**Trans Mountain Pipeline ULC  
Trans Mountain Expansion Project  
NEB Hearing Order OH-001-2014  
Responses to Information Request from  
Metro Vancouver**

**1.1 Liquid Waste Operations****1.1.01 Criteria or Commentary from Metro Vancouver Considered during Corridor Selection****Reference:**

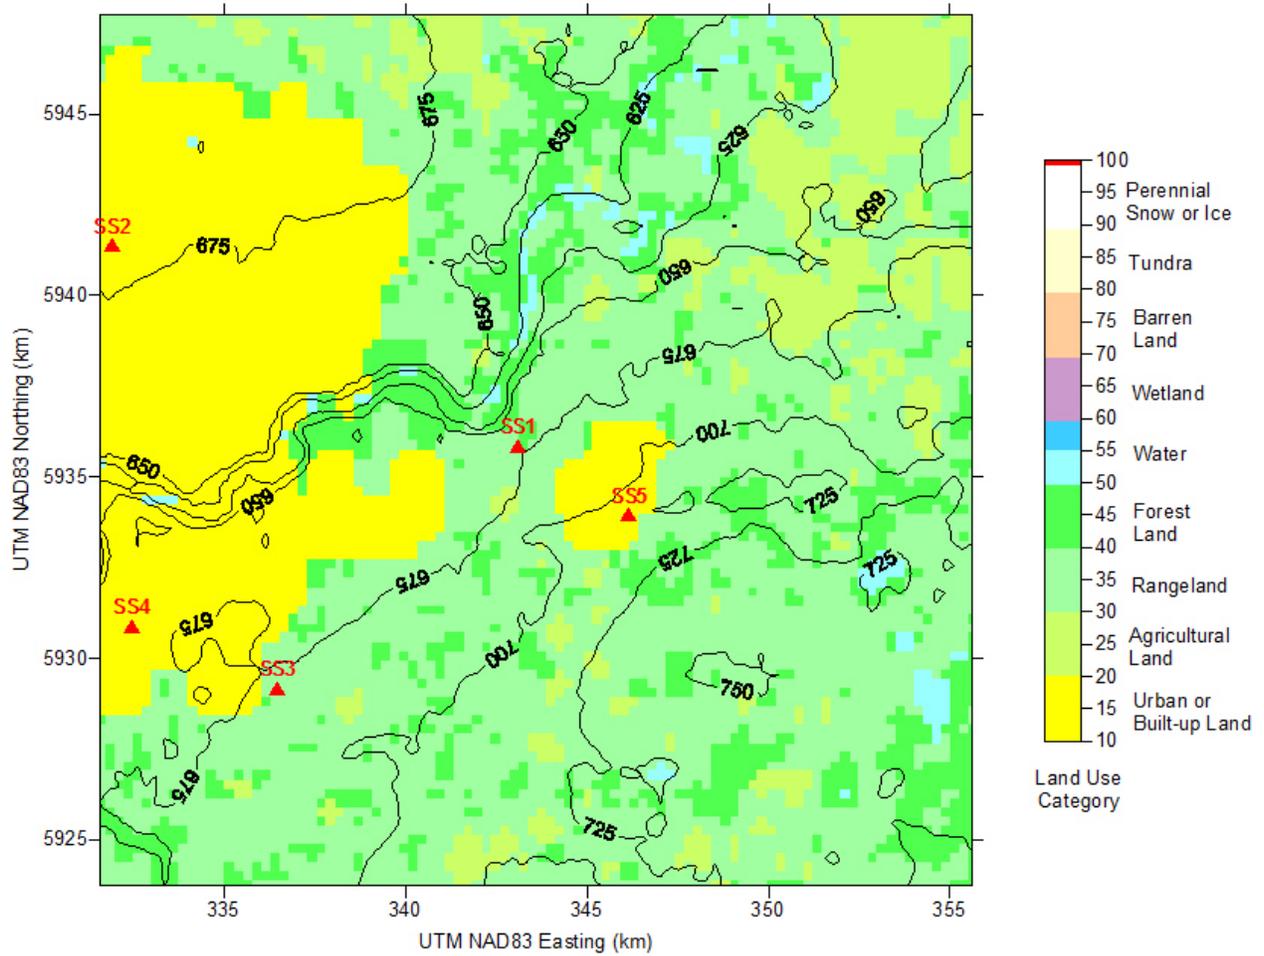
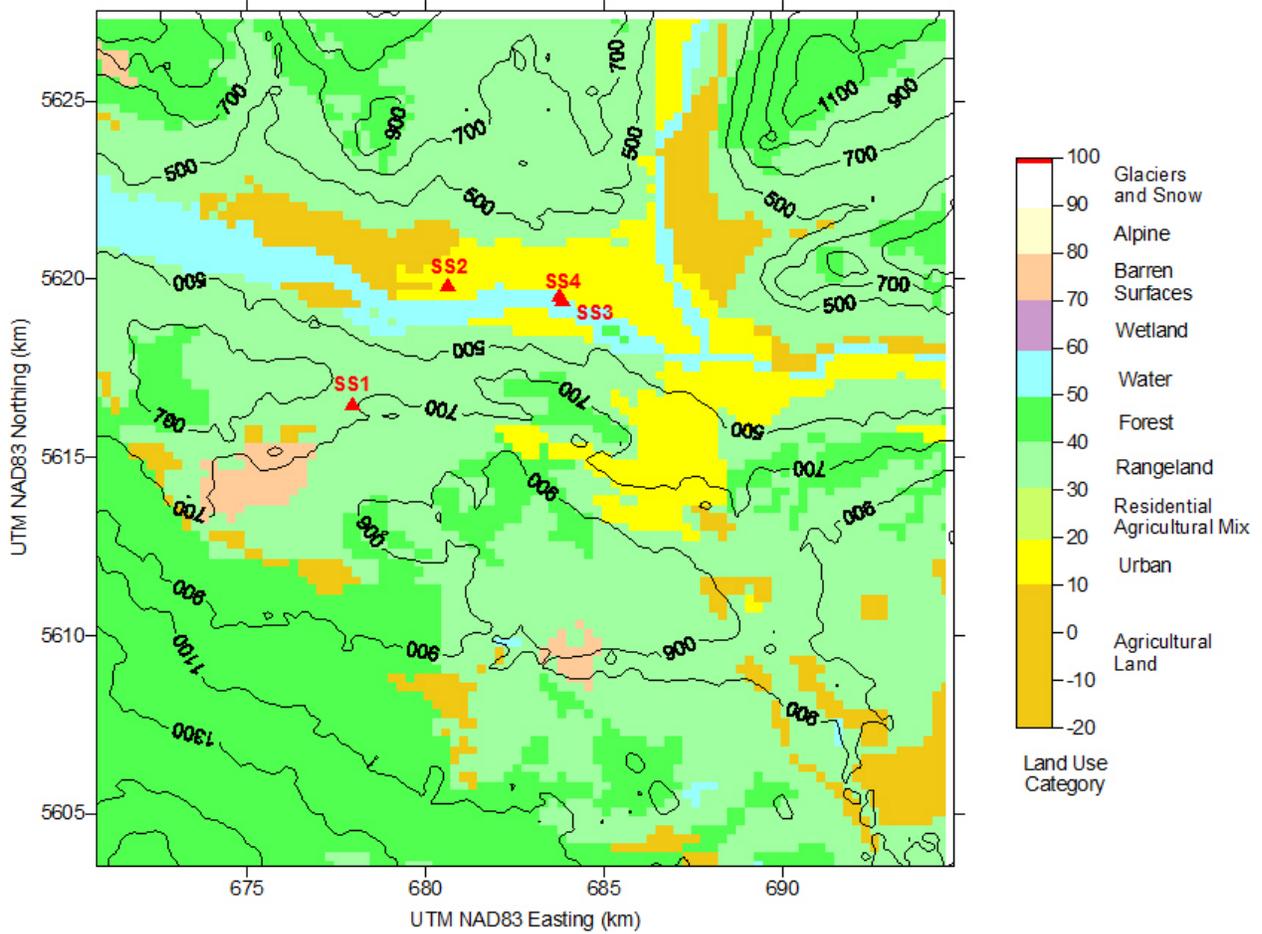
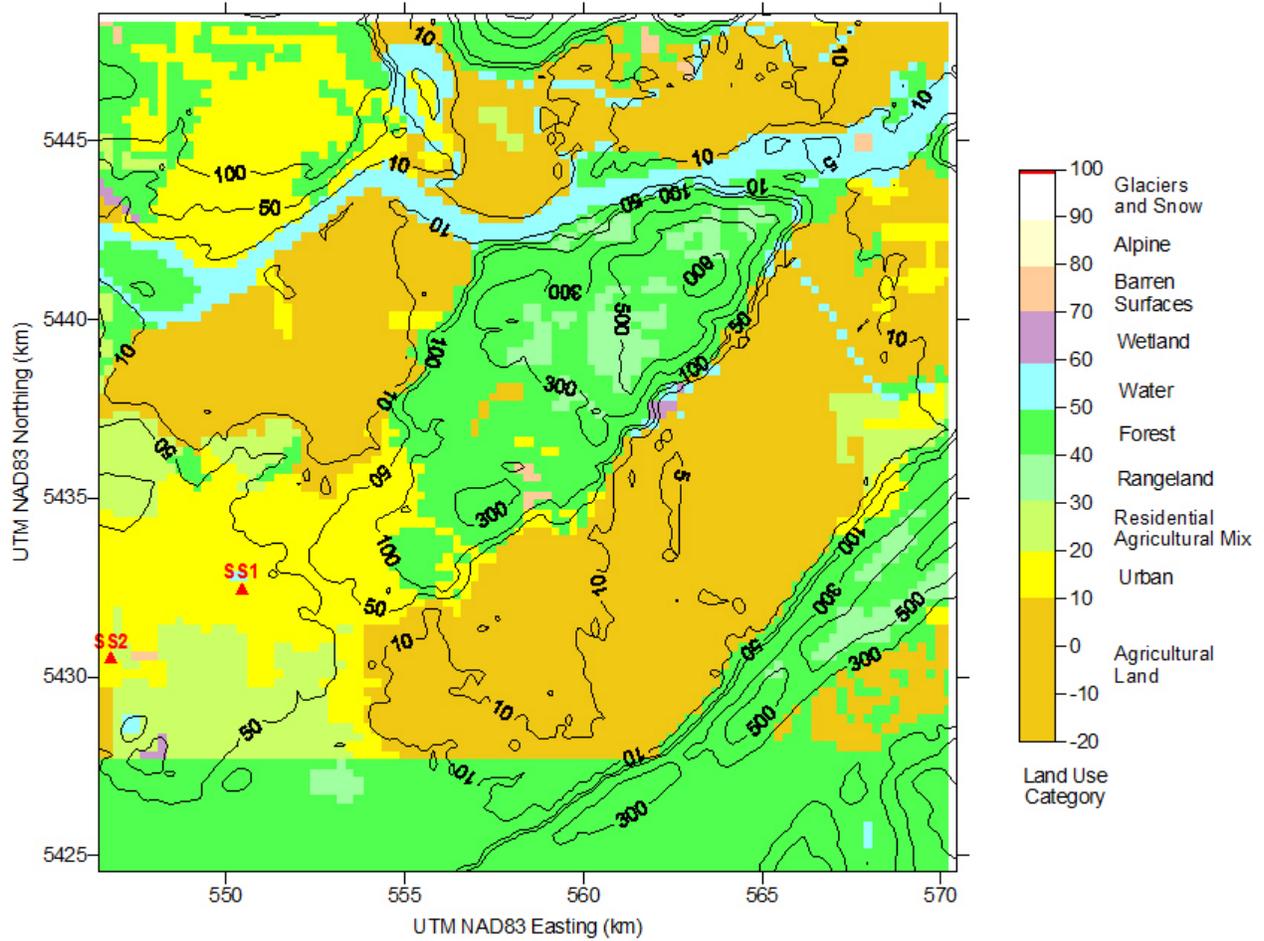
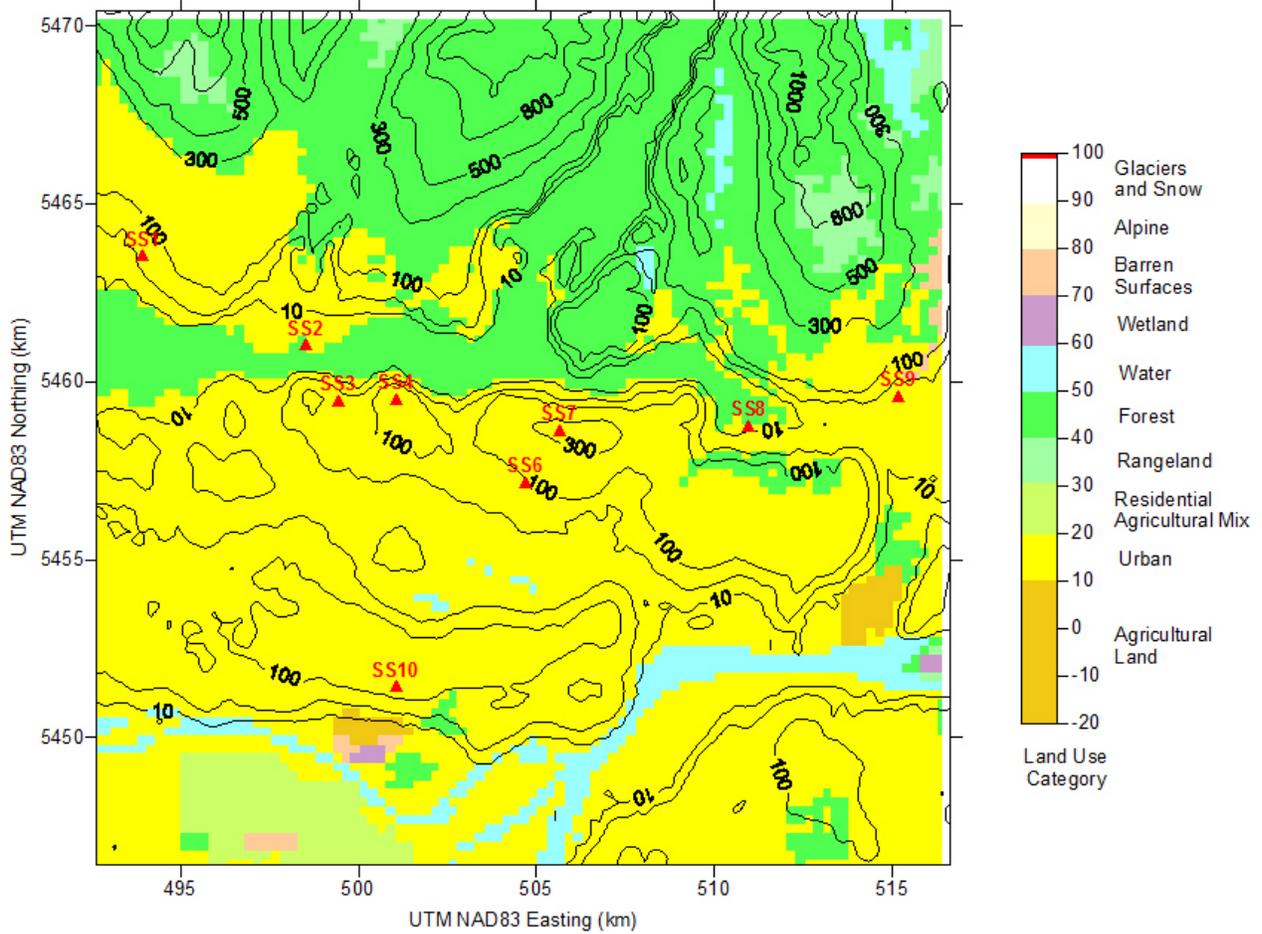
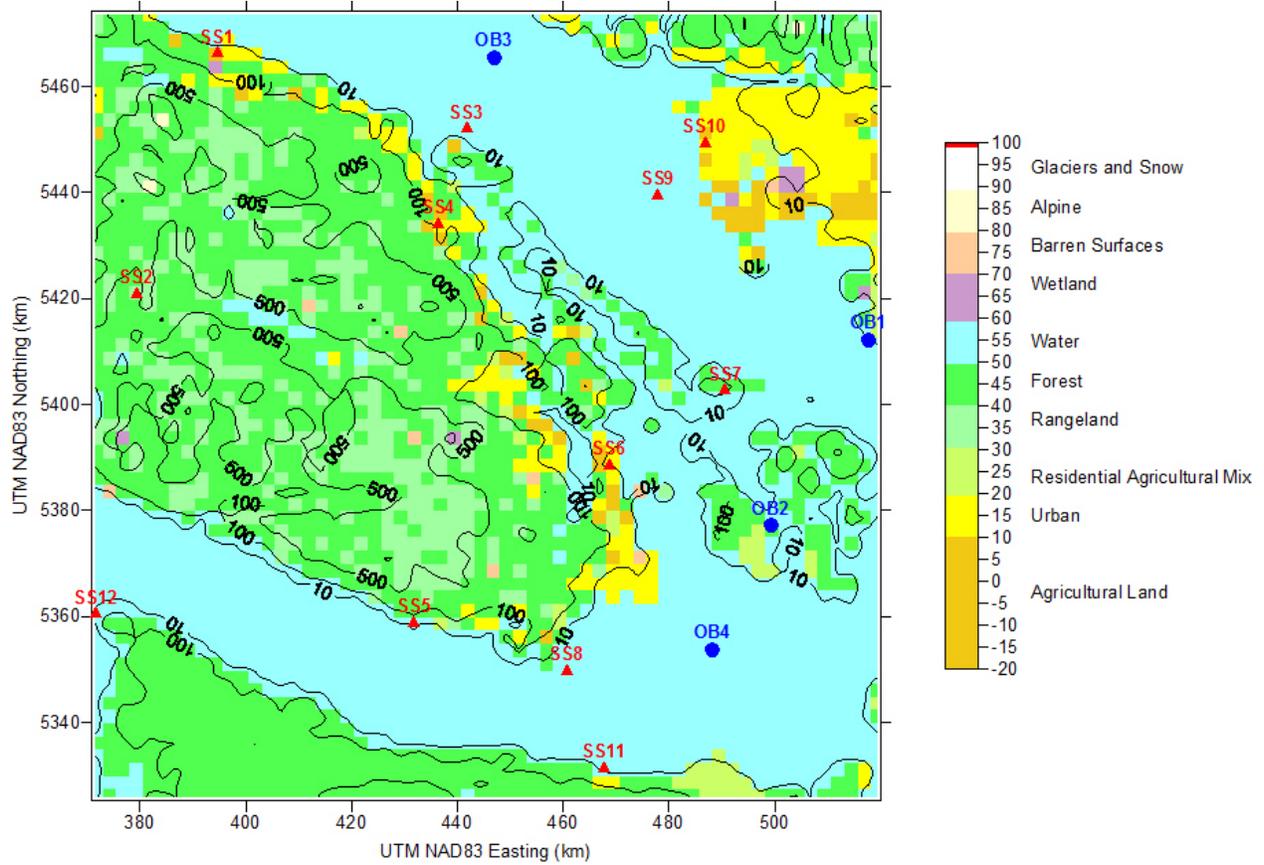
In Figure D.20 of Reference (i) the Burrard Inlet water mass appears to be shown to have an incorrect land-use. In the figure, Burrard Inlet appears to be assigned an urban and residential land-use instead of a water land-use.

- a) The information requested is provided in Figures 1.1.6.11A-1 to 1.1.6.11A-5 below.
